Roofing Inspection Report

Property: Bundalaguah Primary School, [REDACTED] Bundalaguah, VIC 3851

Date of Inspection: April 16, 2025

Prepared by: Holymess Repairs

2. Older Toilet Block

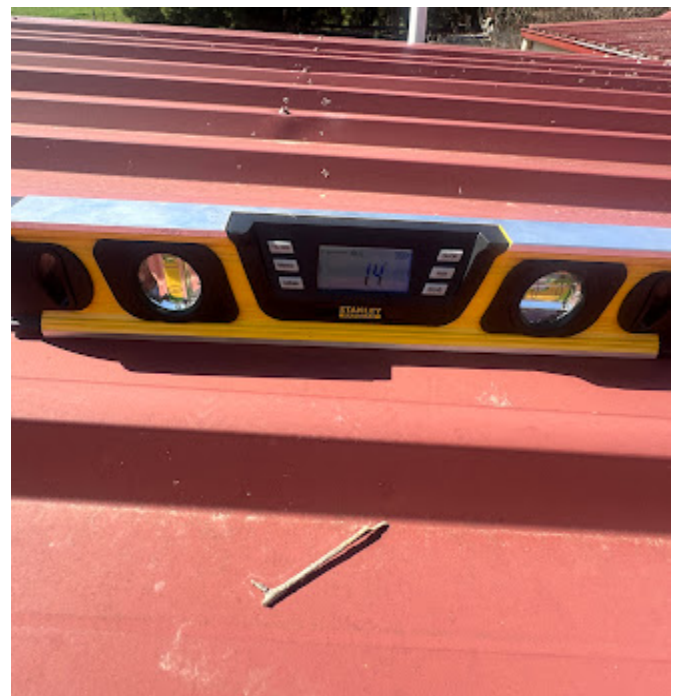
- **Roof Pitch:** The roof pitch is approximately 1.4–1.5 degrees, below the minimum 3 degrees required for a 0.42mm BMT trim deck profile (SA HB 39). This poses a risk of water pooling and leaks.
- **Flashings:** Some flashings cover only one rib, whereas best practice (SA HB 39) recommends covering at least two ribs for stability and to prevent twisting.
- **General Condition:** The roof is structurally sound but non-compliant due to the pitch issue.

Compliance Notes: The roof pitch does not meet SA HB 39 requirements for the profile, risking non-compliance with NCC Part E3P2, which mandates adequate drainage.

Description: Replace the trim deck roof with a 0.48mm BMT clip-lock profile (suitable for 1-degree pitch), install new flashings covering two ribs, and add a rainhead with overflow to the gutter.

Description: Lift the roof, adjust the timber framework to achieve a 3-degree pitch, reinstall the existing trim deck, and replace flashings to cover two ribs. Add a rainhead with overflow.

3. Walkway Roof

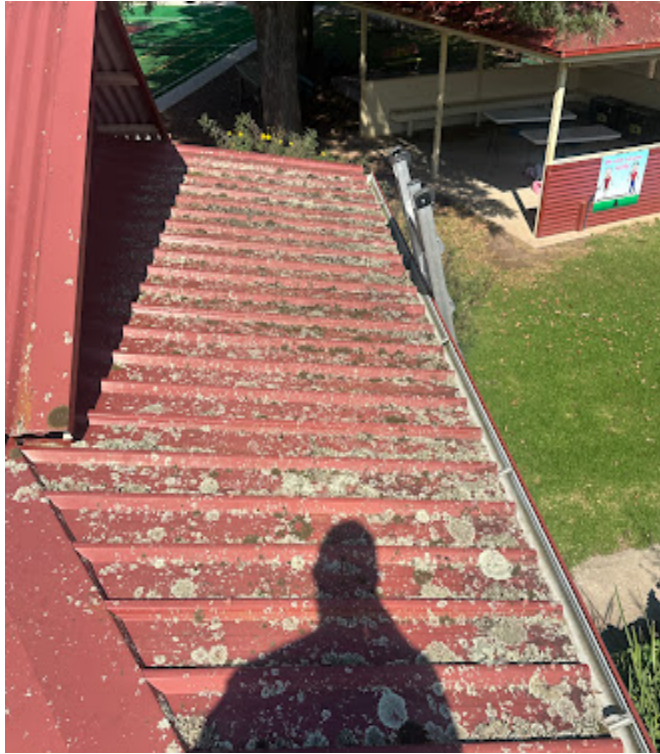
- **Pitch:** The roof pitch is 4 degrees, which is compliant and sufficient for water runoff.
- **Box Gutter:** The box gutter is level, causing water to pool, and lacks overflow provisions, which is non-compliant. It does not meet the minimum dimensions (200mm bottom, 100mm top) per AS/NZS 3500.3.
- **Rainhead:** The rainhead is blocked and lacks an overflow, violating NCC Part E3P1.
- **Roof Sheets:** The ends of the sheets are not turned down, increasing the risk of water ingress via capillary action.
- **General Condition:** The roof is dirty, with debris in trays, and requires a high-pressure clean.

Compliance Notes: The box gutter and rainhead issues contravene NCC Part E3P1–E3P4, which require adequate stormwater disposal and overflow provisions.

Description: Lift the roof, replace the box gutter with a compliant design (200mm bottom, 100mm top, correct fall), install a rainhead with overflow, turn down sheet ends, clean the roof, and repair damaged downpipes with inspection openings.

Description: Install a sump and downpipe at the low end of the box gutter, add a rainhead with overflow, turn down sheet ends, clean the roof, and repair downpipes with inspection openings.
